County Permit Review Worksheet

GWS Septic System Design Review

RE: Request for an Improvement Permit for Lot 37 at The Retreat at Latta Plantation off of Sample Road.
MCHD File #6775B

Design Specifications for Lot 37 off of Sample Rd.
MCHD File # 6775B

Scale: 1 inch equals 50 feet	S&ME	Faison-Sample Road, LLC	FIGURE
Drawn by: JBP		Lot 37	1
Reviewed by: Jeremy P. Michelone, RS		Mecklenburg County, NC	
Date: March, 2007	ENVIRONMENTAL SERVICES · ENGINEERING · TESTING	S&ME Project #1588-05-091

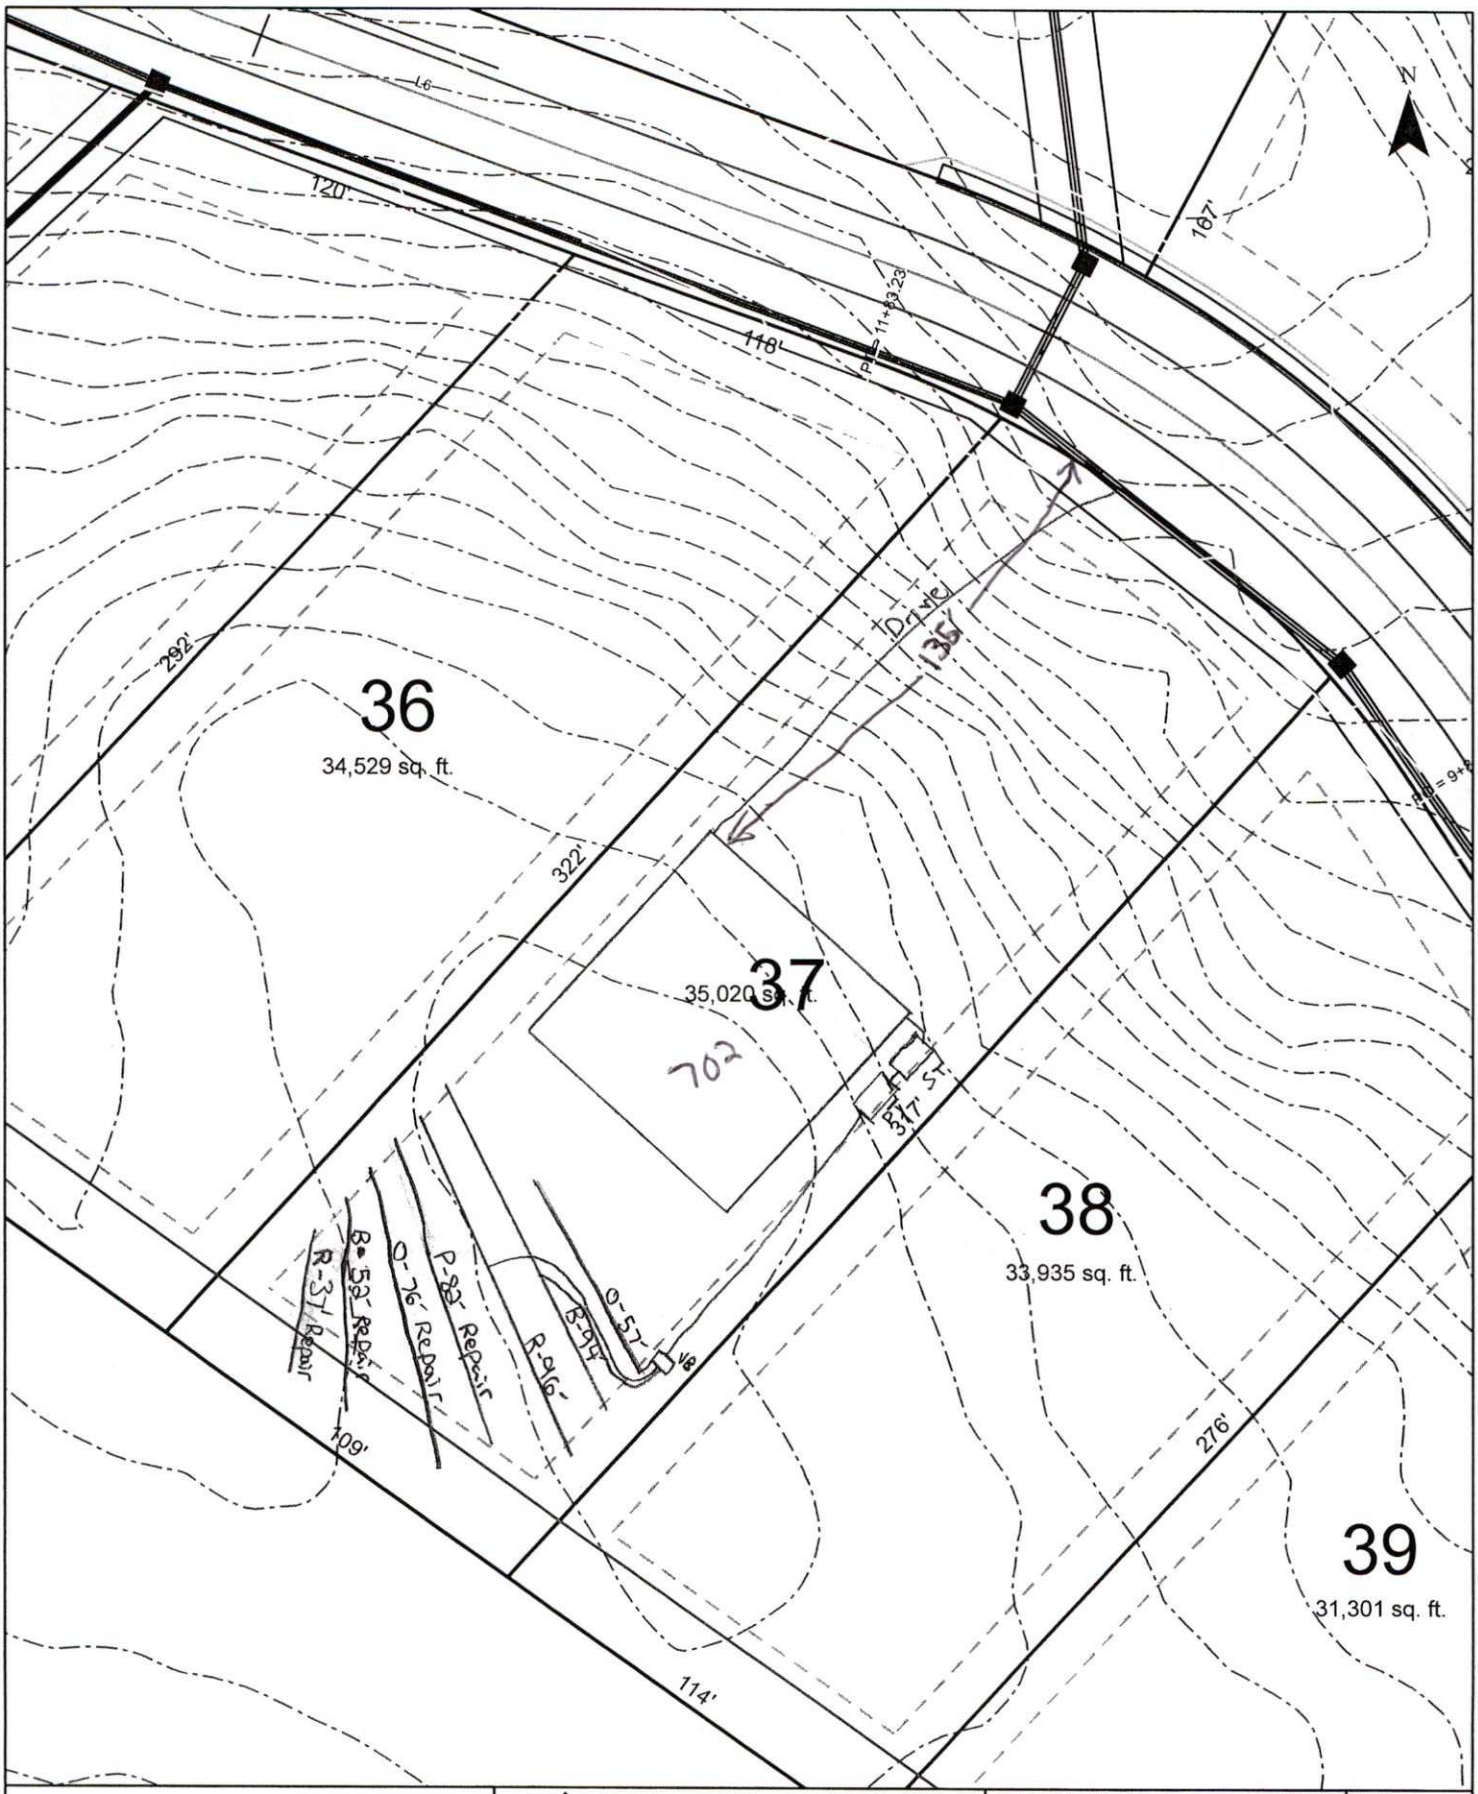
1. Install system using 3 ft. wide trenches.									
2. Install drainlines on 9 ft. centers, level, and on contour.

3. System design requires effluent pump for distribution.								
4. 100% Repair area is required.
